STATE OF IDAHO
DEPARTMENT OF WATER RESOURCES
BENEFICIAL USE FIELD REPORT

Supplemental Exam

Permit No. 31- 7567
208 390-4448 cell
Phone No. 663-4448

Supplemental Exam 31- 7567
5/11/2006

Place of Use

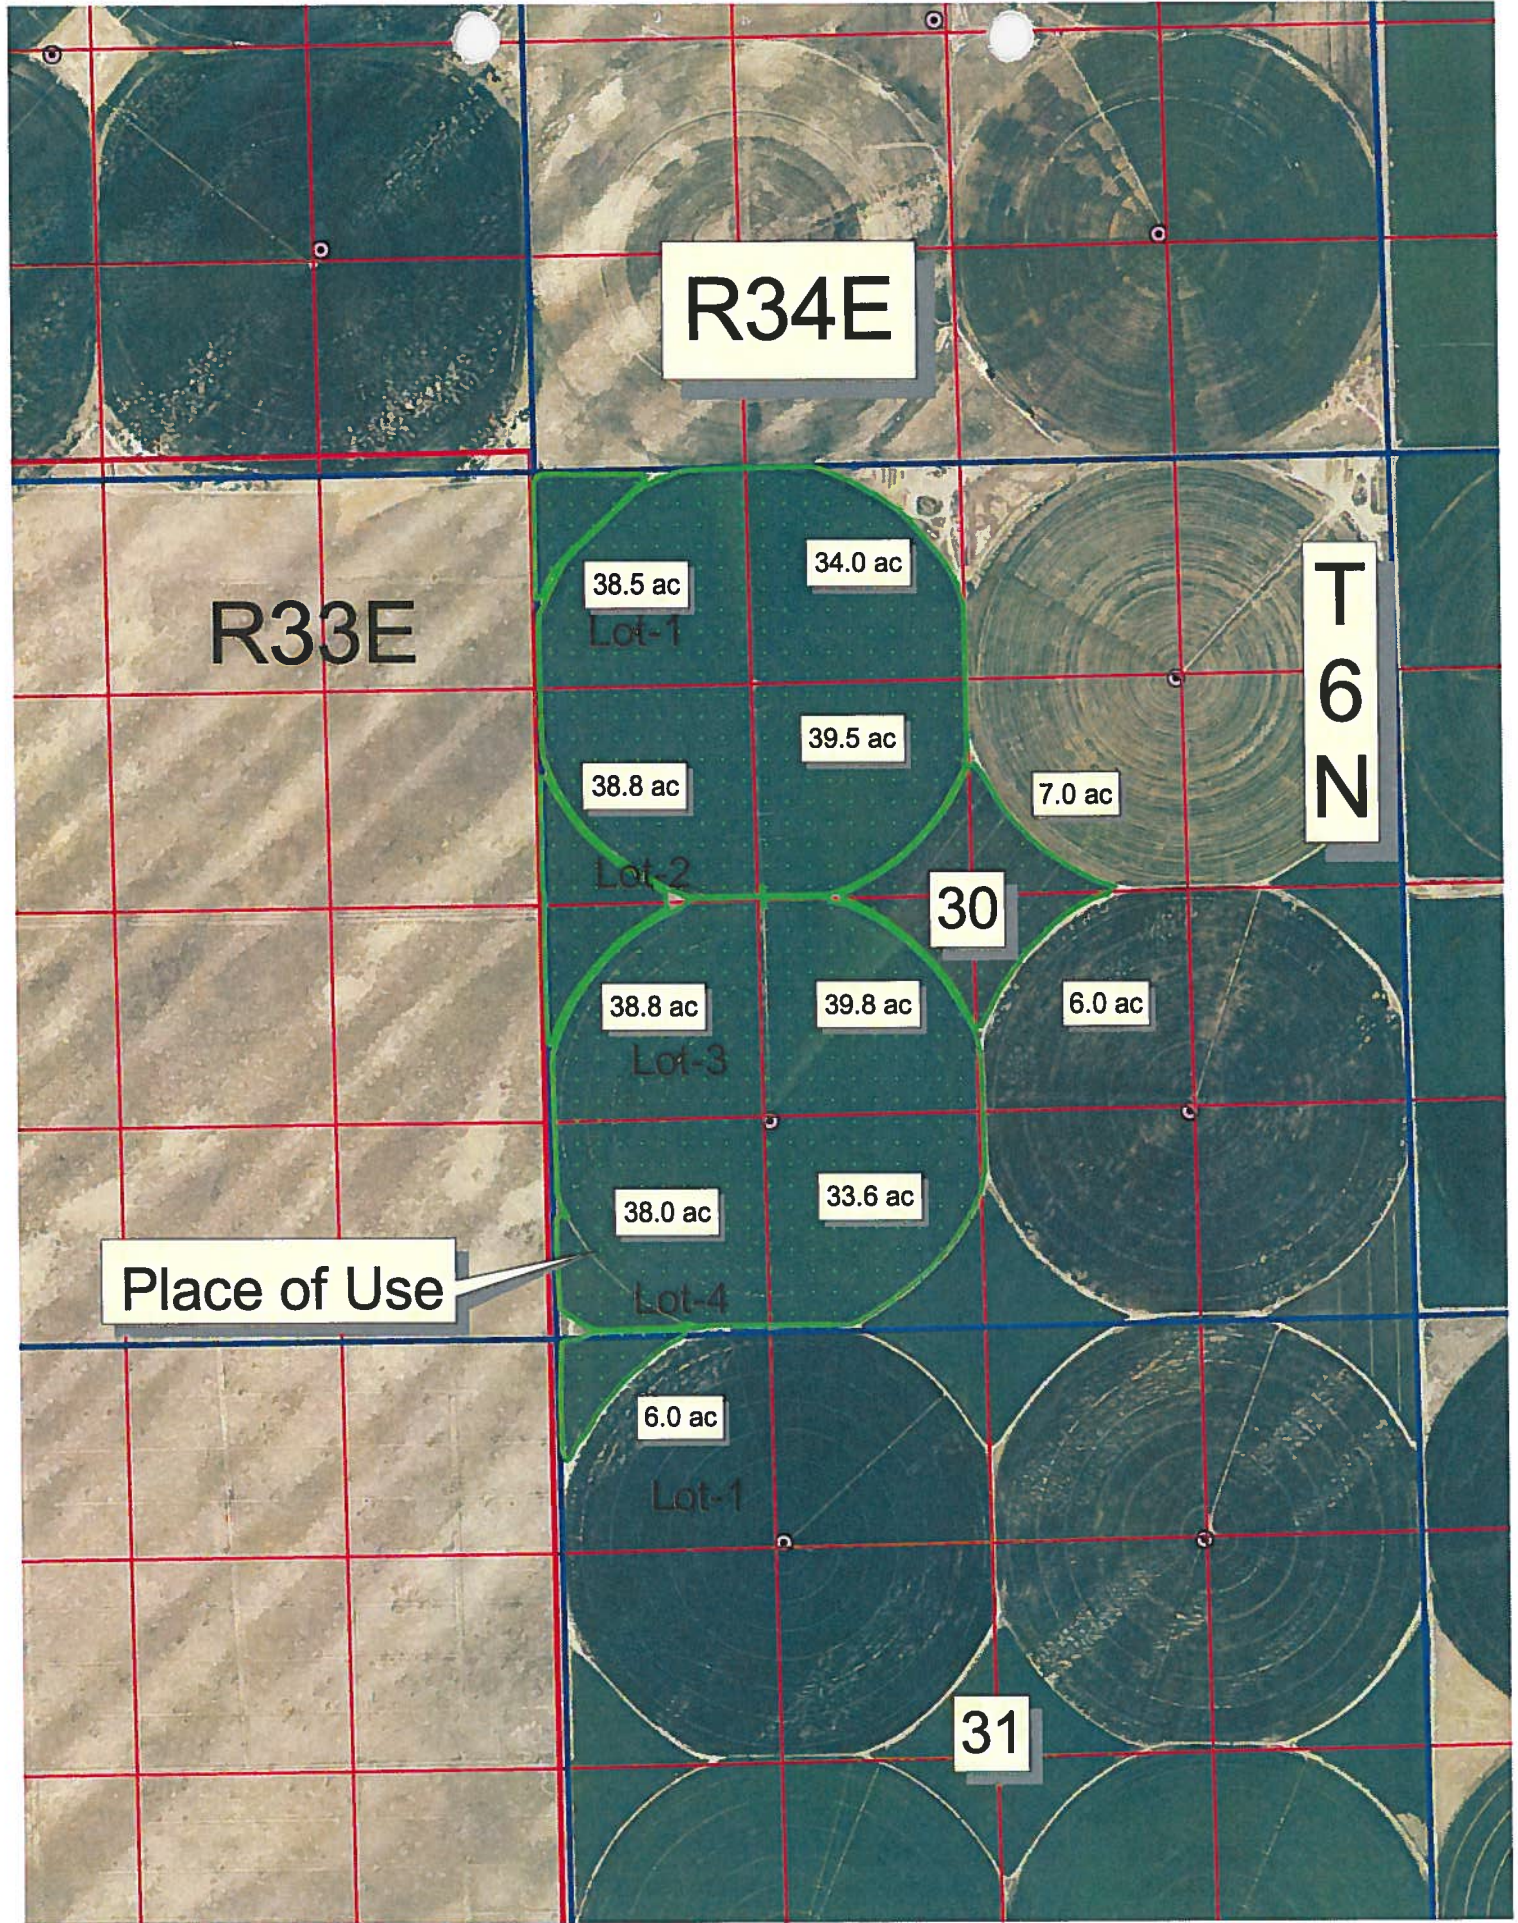
In discussing the place of use with Mr. Wood on 5/11/2006 & review of the field exam I recommend that the place of use should be changed to the 320 acres as shown in Part C.2 of this supplemental exam.

Mr. Wood will need to file ~~a~~ two transfers on 31-7560B. One transfer will change the place of use from the SW NE (corner) Sec 30 to the corner of the SE SW Sec 30. The second transfer will split 31-7560B to change the point of diversion for the corner of NW SE Sec 30 to the well in the SE SW Sec 30.

Note 31-7560B proof report indicates the corner of the SE NE Sec 30 but Arc View Shape has the place of use as the corner of the SW NE Sec 30. The 1st transfer can correct the proof report.
